Approved plan of the Committee  
on the 10 Aug 1892, length modified from 105' to 110'.

Steam Vessel 16/5 '92.

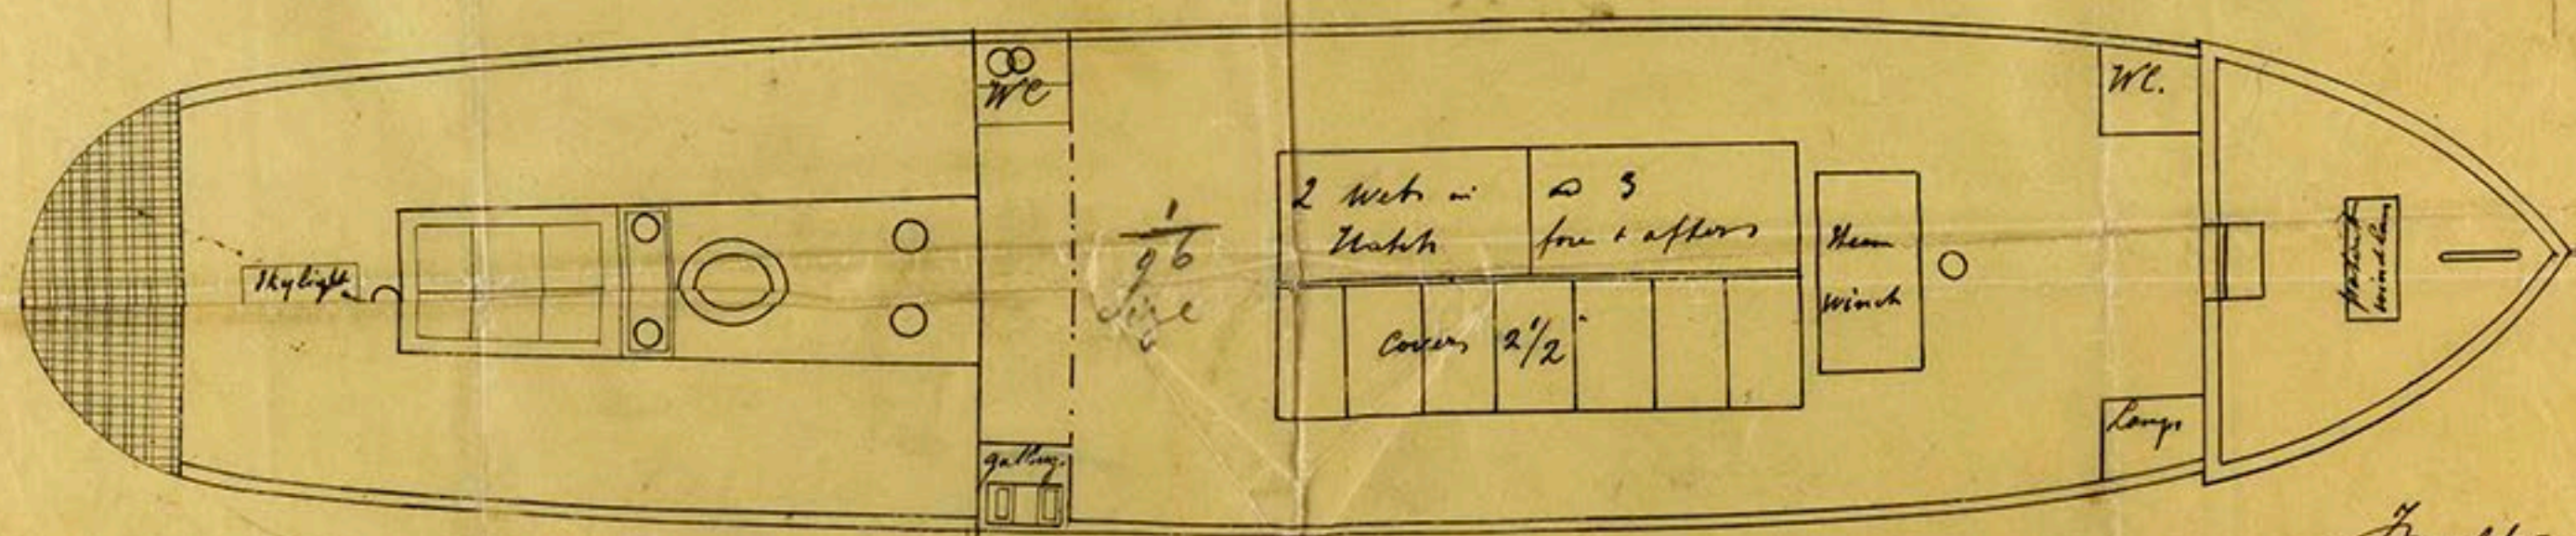
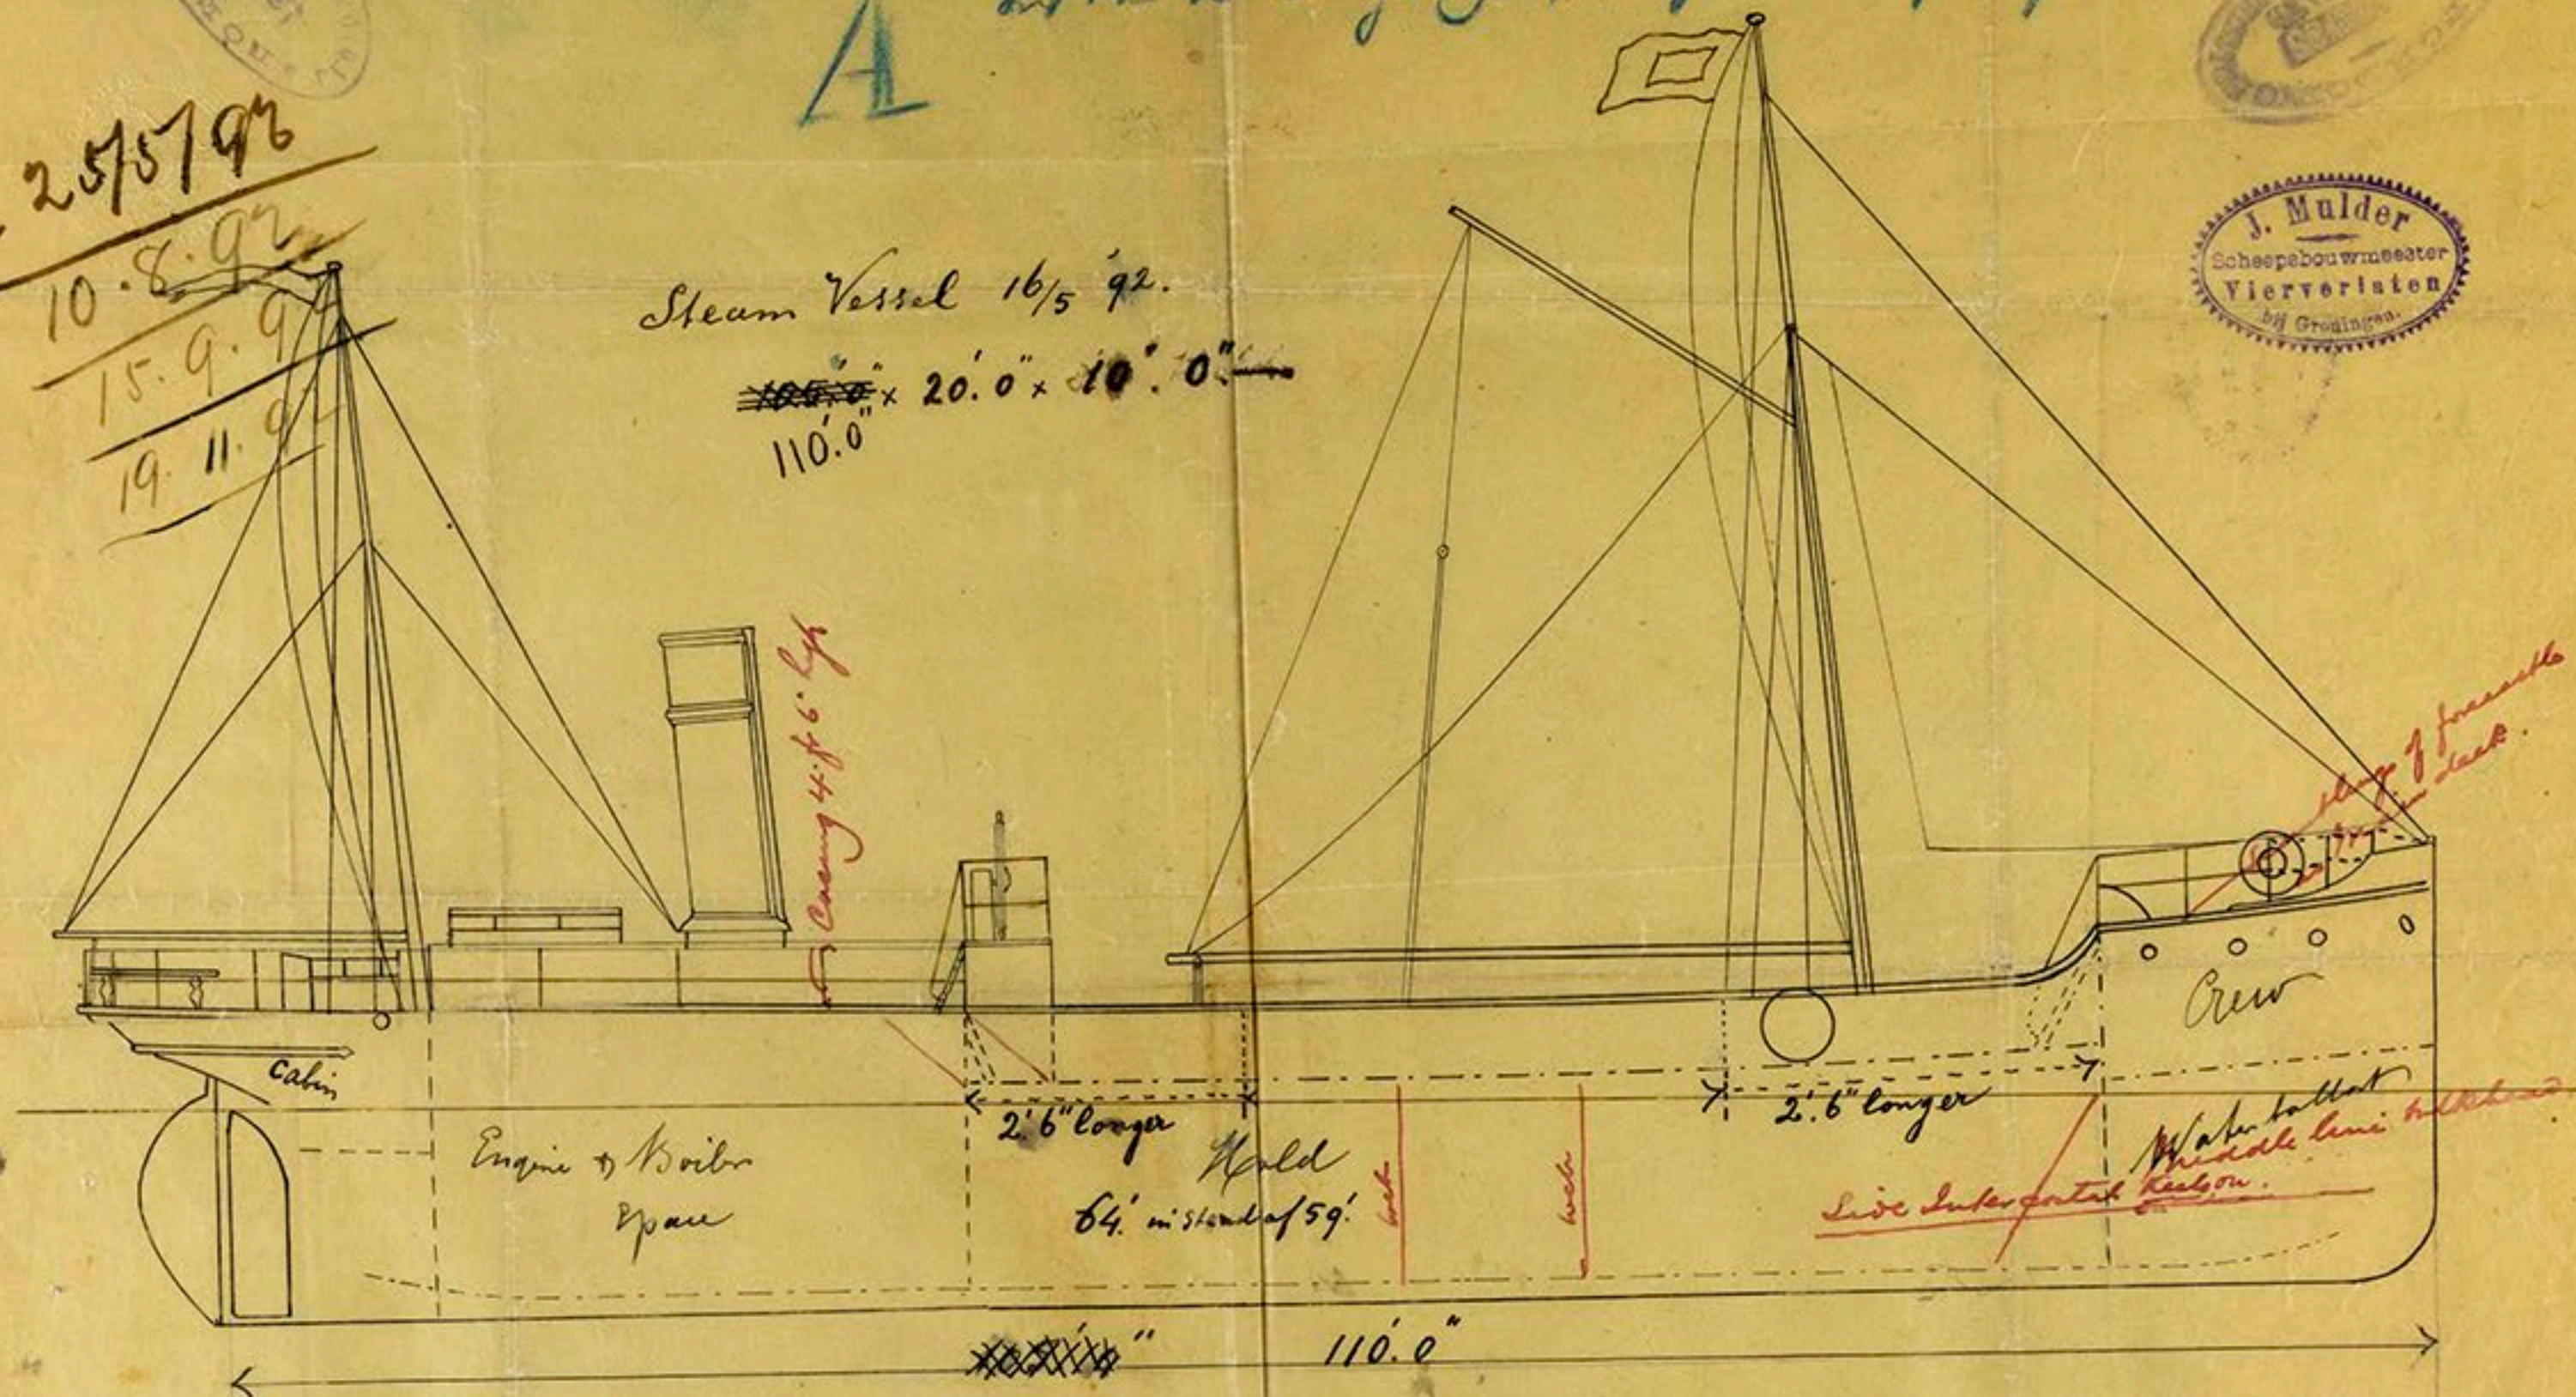
~~105.0~~ x 20.0 x 10.0  
110.0
